WORCESTER COUNTY PLANNING COMMISSION AGENDA

III. Major Site Plan Review - Woodside Solar Project – 5589 Woodside Lane

IV. Major Site Plan Review – Snow Solar Project – 6413 Timmons Road

Re: Woodside Solar Comment Package Response
Letter
Woodside Solar Project
5589 Worcester Hwy,
Snow Hill, MD 21863

Sheet 3

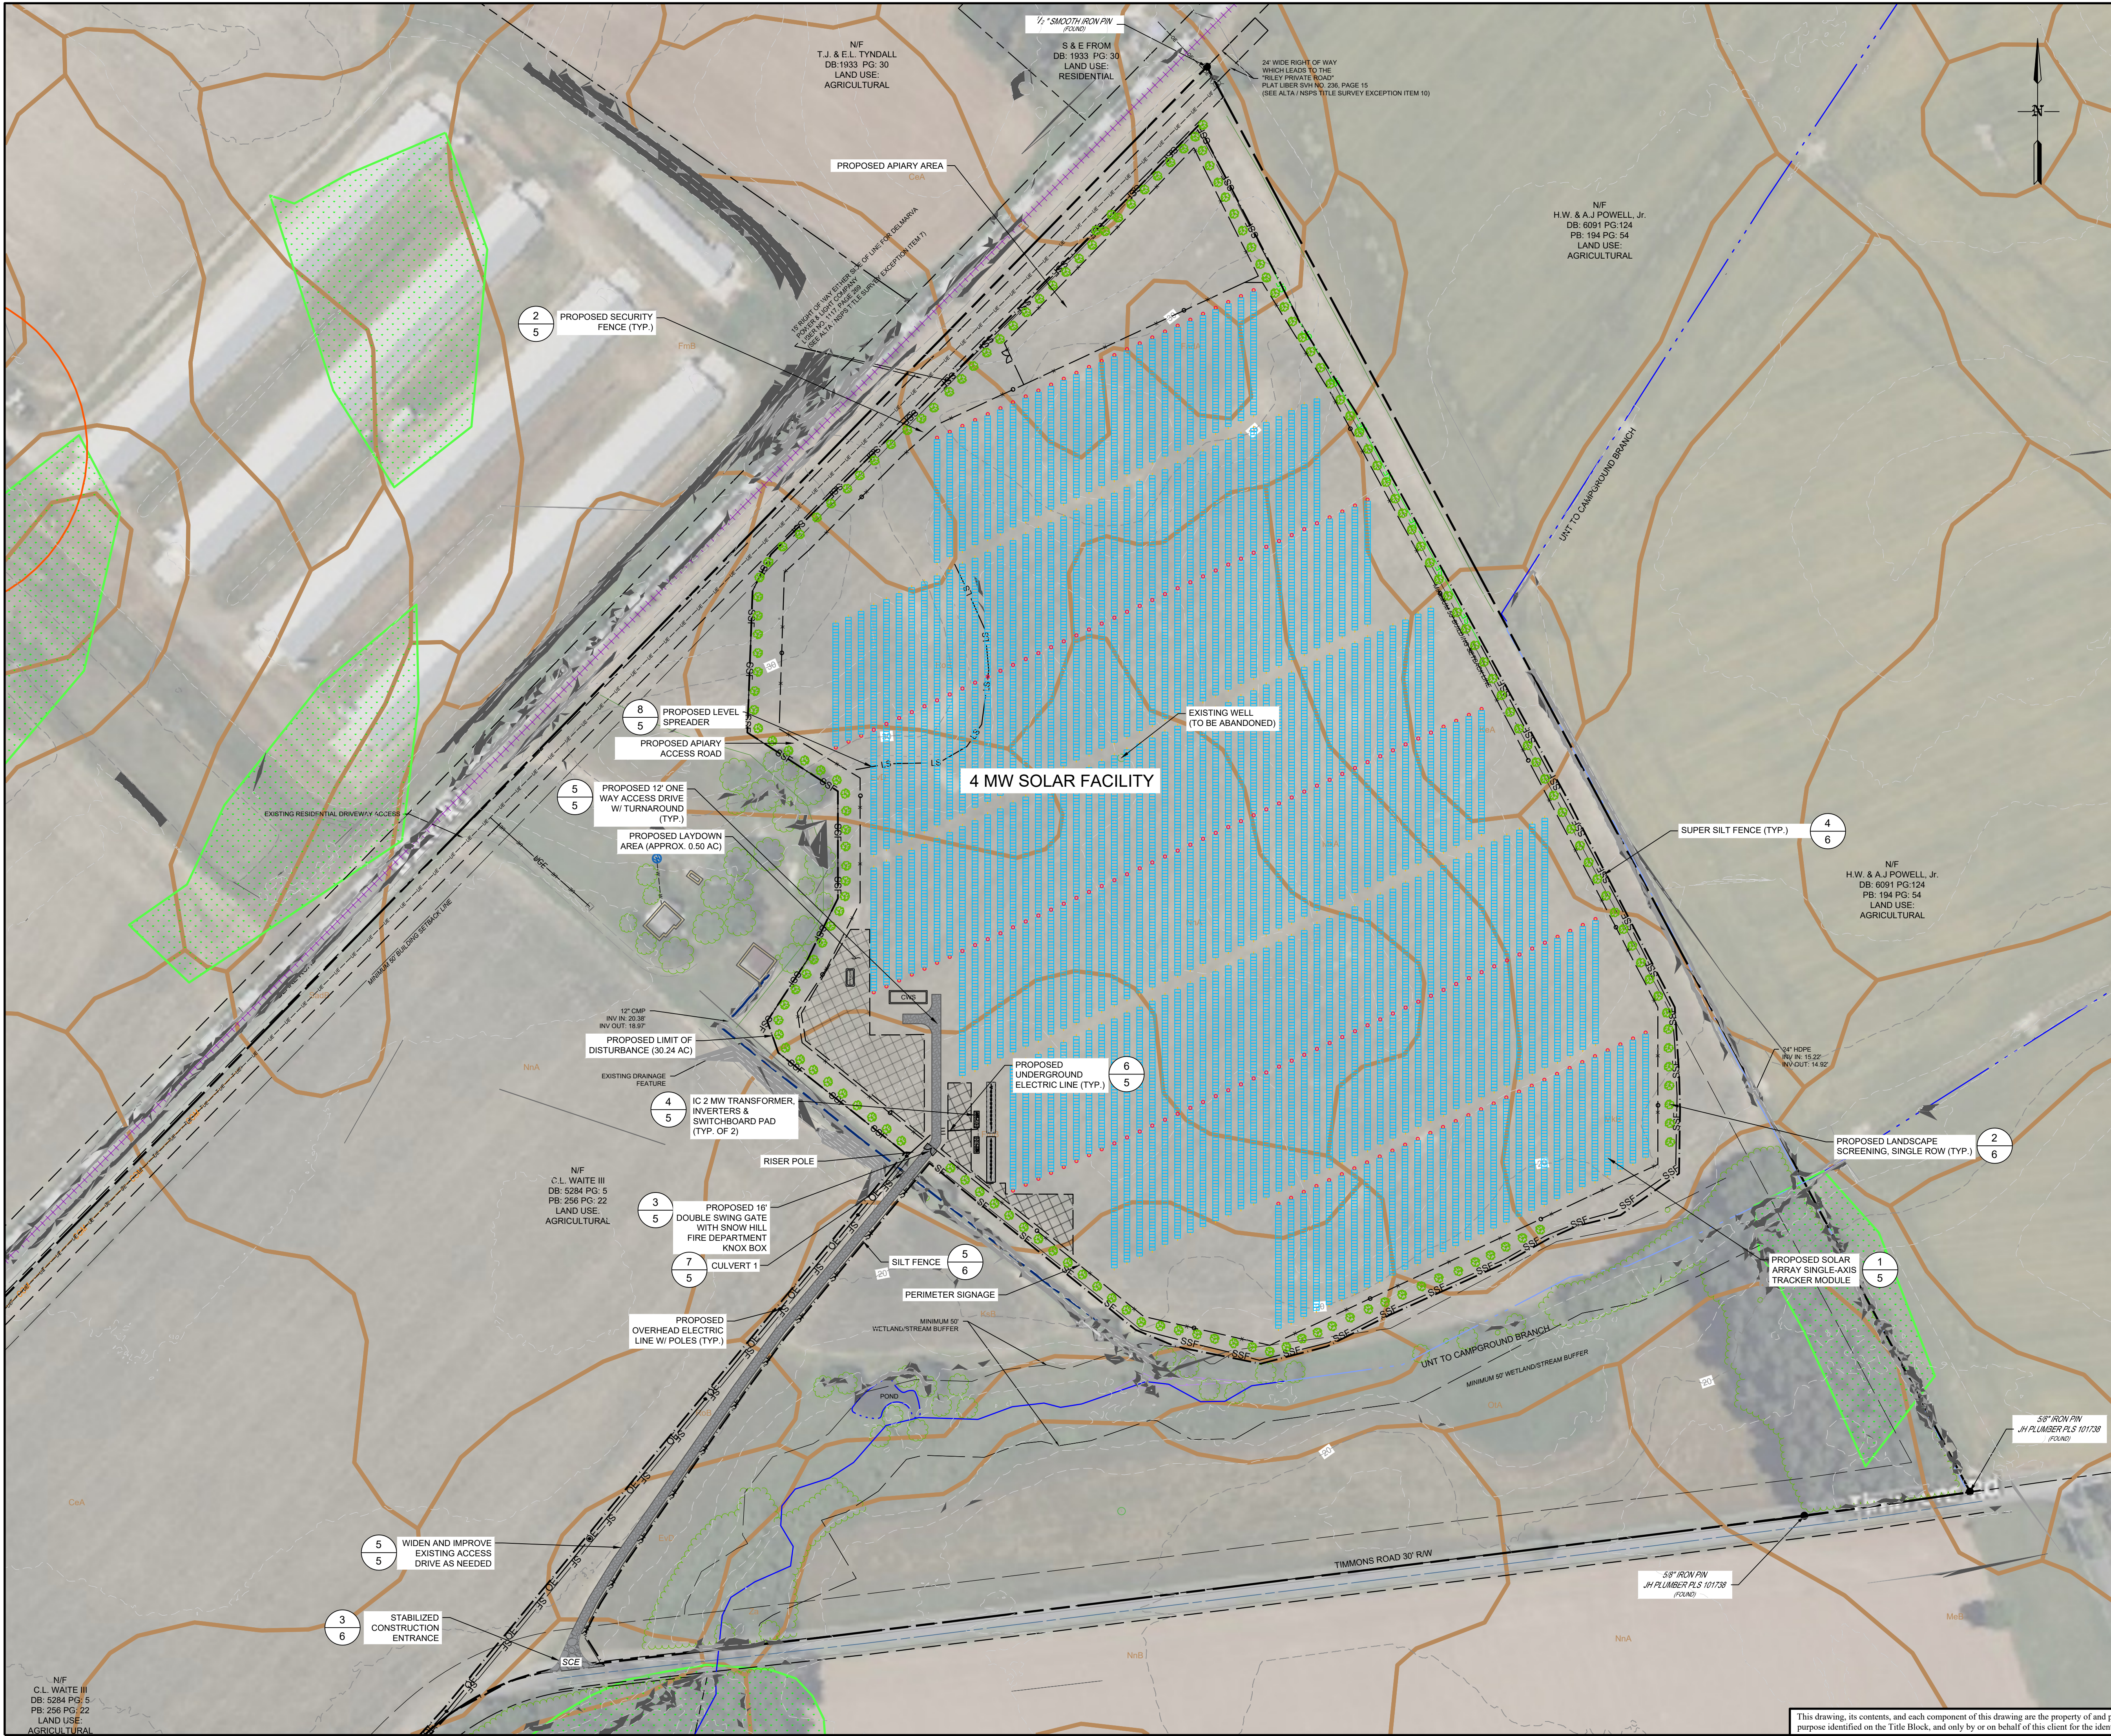
Comment 1: Sheets 3 & 4: Please clarify if the proposed 12' wide access drive will be for one-way traffic. If it is for two-way traffic, then it will need to be widened to 20.'

Comment 2: Sheets 3 & 4: Please show the signage that is shown on typical detail #9 on sheet 5.
